Technical Memorandum

**RE: Waterloo Estate (South)
Environmental Wind Tunnel Study – Response to Submissions**

This document has been prepared by SLR Consulting Ltd (SLR) as an addendum to the previously issued quantitative wind assessment for the proposed development within the Waterloo Estate (South):

The addendum has been developed in response to submissions received during the public exhibition of the Waterloo Estate (South) Concept SSDA (93222706) and concurrent rezoning.

Figure 2 Proposed additional wind measurement points for future detailed SSDAs

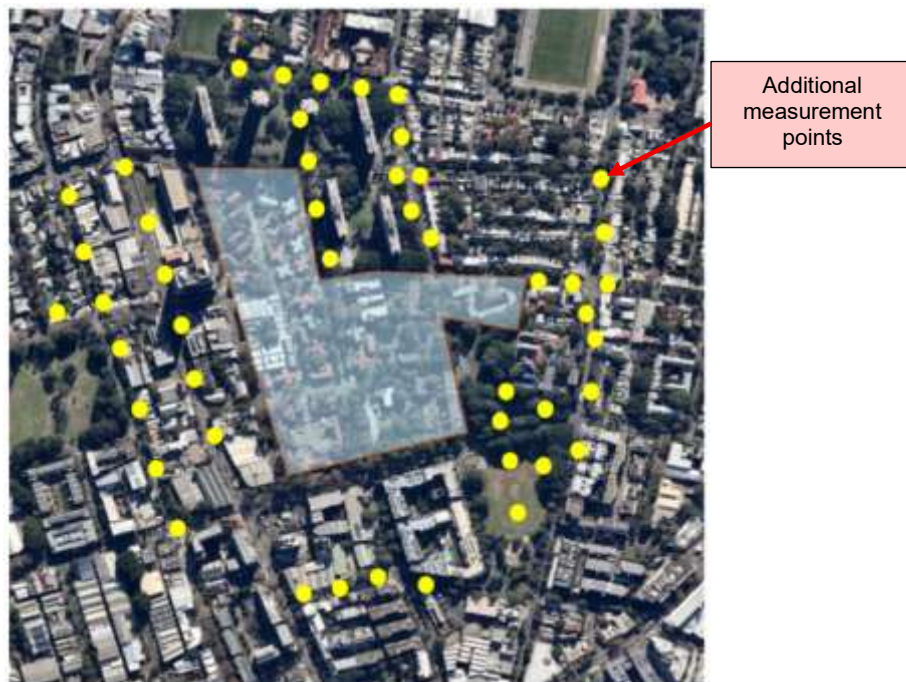
5. The Environmental Wind Tunnel Study has not provided predicted comfort levels for existing development surrounding the site. The Department requests that additional wind testing be undertaken to identify predicted comfort levels across surrounding streets and key public domain areas, including Waterloo Park and Waterloo Oval, and demonstrate how appropriate design responses and/or mitigation measures would achieve suitable wind comfort outcomes, including a 'sitting' comfort level where applicable.

- As shown in the following figure, the majority of wind measurement points are strategically located in the immediate vicinity of the proposed development, where the influence of the building mass is expected to be greatest. These locations directly capture development-induced wind effects, including façade downwash, corner acceleration, wind channelling, and shielding, providing a representative assessment of the pedestrian wind environment. In contrast, measurement points located near the outer boundary of the proxy (approximately 900 m from the site) are predominantly influenced by the surrounding urban environment rather than the proposed development and are therefore unlikely to experience any measurable or practically significant changes in wind conditions attributable to the development.

- The existing measurement points located along the edges of the Parks, including Waterloo Park and Waterloo Oval, are positioned at the locations closest to the proposed development and are therefore considered appropriate for assessing the potential influence of the development on public open spaces. As these edge locations are the first areas within the park to experience any development-induced changes in airflow, they provide a conservative and representative indication of potential wind impacts within the park.

The current assessment demonstrates that the standing comfort criterion is achieved at these edge locations. Given that wind speeds would be expected to further reduce with increasing distance into the park due to the combined effects of separation from the development and the sheltering provided by the mature and dense tree canopy, it is likely that the sitting comfort criterion would also be achieved within much of the park.

Waterloo Park and Waterloo Oval are recognised as a high-sensitivity recreational receptor accommodating activities such as walking, jogging, outdoor exercise, passive recreation, children's play and organised sporting activities. Notwithstanding this sensitivity, the assessment results indicate that the development does not result in adverse wind conditions at the park boundary, being the area most susceptible to development-related impacts.

On this basis, and in our professional opinion, additional wind tunnel testing of the Master Plan is not warranted at this stage. For future SSDAs, once the detailed design of individual development blocks has been finalised, additional measurement points, as shown in Figure 2 below, may be incorporated into the accompanying environmental wind assessment to further verify this conclusion if required.
